## REDEVELOPMENT OF HARBOURSIDE SHOPPING CENTRE SSD 16\_7874

I would like to lodge a formal object to this proposal on the grounds that the scale, massing and nature of the development have an unacceptable impact both on the visual setting of the Pyrmont Bridge but, more importantly, will have a deleterious effect on the character and original planning intent of Darling Harbour.

These illustrations (3 & 4) show how rendering can be used to minimise the appearance of new development. Glass is neither white, nor transparent.

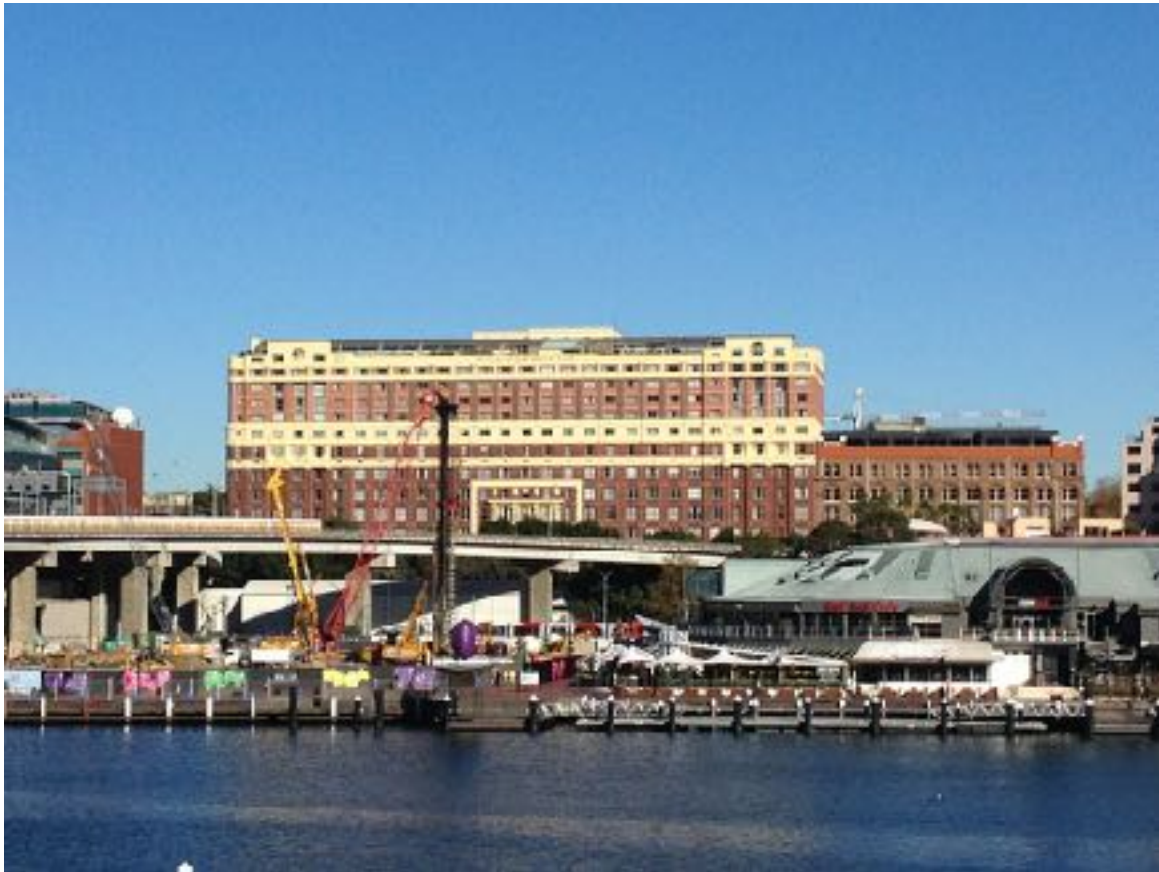
Note also that the figures demonstrate that the concept proposals have been artificially rendered to minimise the visual impact, scale and setting of the buildings. Note the contrast between the new tower by the convention centre as built and the rendering (see figures 3 & 4)

Figures 5 and 6 illustrate the gradual loss of visual relationship between the Goldsbrough building and the current harbour.

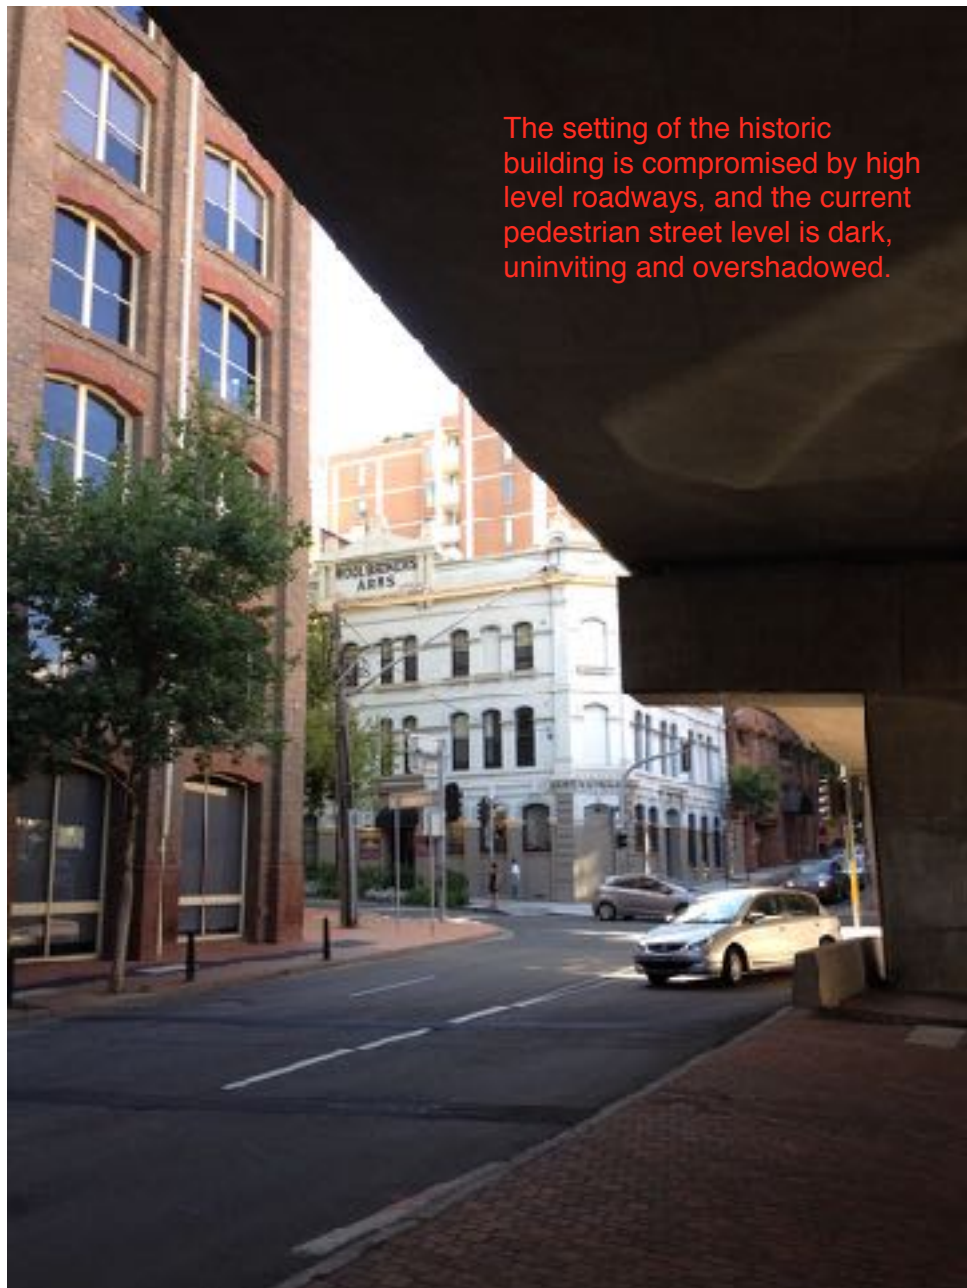
now been completely isolated from Darling Harbour and is no longer visible from the water (see Figs 6 & 7).
